Access Compliance Report Public Rights-of-Way (Curb Ramps)

Main Street: CRESTKNOLL_DR		Cross Street: GLENDALE_DR		Location:	NW
ADA ID: RPAT210923090808	Ramp Type: Type 4 - Parallel	Initial Pass/Fail: Fail	Overall Compliance: No	Severity Score:	15
Codes/Mitigation Info/Possible Solution			Field Measurements/Component Compliance

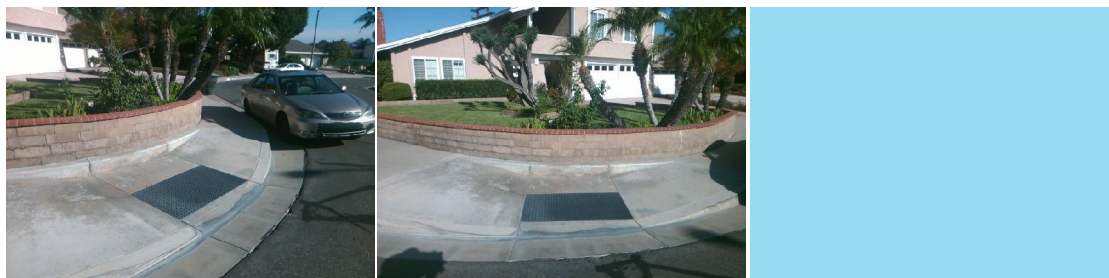
Compliance	Description	Data	Compliance	Description	Data
N/A	Ramp Length LT (in)	87	N/A	Ramp Length RT (in)	86
Yes	Ramp Width LT (in)	78	Yes	Ramp Width RT (in)	65
No	Ramp Run Slope LT (%)	8.4	No	Ramp Run Slope RT (%)	10.5
Yes	Ramp Cross Slope LT (%)	1.5	Yes	Ramp Cross Slope RT (%)	1.1
N/A	Landing Present	N/A	N/A	DWS Provided	N/A
N/A	Landing Length (in)	N/A	N/A	DWS Contrast	N/A
N/A	Landing Width (in)	N/A	N/A	DWS Length (in)	N/A
N/A	Landing Run Slope (%)	N/A	N/A	DWS Full Width	N/A
N/A	Landing Cross Slope (%)	N/A		DWS Offset Type	N/A
N/A	Landing Movement Obstructed?	N/A	N/A	DWS Offset Left (in)	N/A
	Landing Movement Type	N/A	N/A	DWS Offset Right (in)	N/A
N/A	Landing Shared	N/A			
N/A	Clear Space	Yes			
N/A	Clear Space To Crosswalk (in)	N/A			
N/A	Marked Crosswalk 1	No	N/A	Marked Crosswalk 2	No
	Crossing 1 Direction	S		Crossing 2 Direction	E
	Marked Crosswalk 1 Width (in)	N/A		Marked Crosswalk 2 Width (in)	N/A

Remove & Replace Curb Ramp With Two New Directional Ramps or Equivalent.
